UNITED STATES PATENT AND TRADEMARK OFFICE

10/590,913

DETAILED ACTION

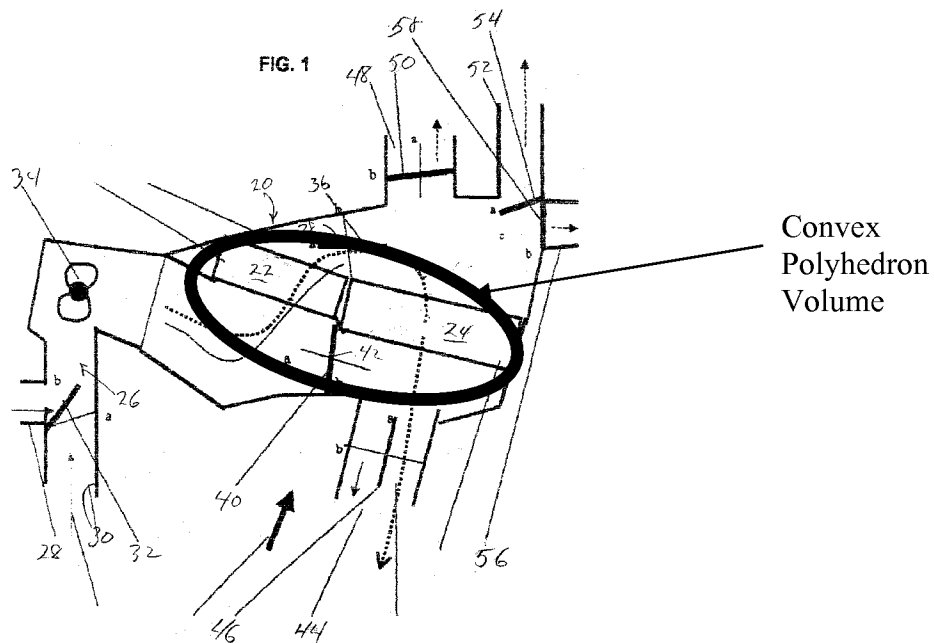
Alber et al teach said at least one first heat exchanging device (ref 22) and said as least one second heat exchanging device (ref 24) are both located within a volume defined by a convex polyhedron, said volume lying entirely inside said housing (ref 20) (See annotated Figure 1 below; Paragraph 35). In view of Alber et al's teachings, it would have been obvious to one of ordinary skill in the art at the time of invention to locate the two heat exchangers in the same area since it would allow for a reduced overall size of the housing, which would reduce the amount of material needed to create the constructional unit.

Alber et al teach said at least one first heat exchanging device (ref 22) and said at least one second heat exchanging device (ref 24) are both located within a volume defined by a convex polyhedron, said volume lying entirely inside said housing (ref 20) (See annotated Figure 1 above; Paragraph 35). In view of Alber et al's teachings, it would have been obvious to one of ordinary skill in the art at the time of invention to locate the two heat exchangers in the same area since it would allow for a reduced overall size of the housing, which would reduce the amount of material needed to create the constructional unit.
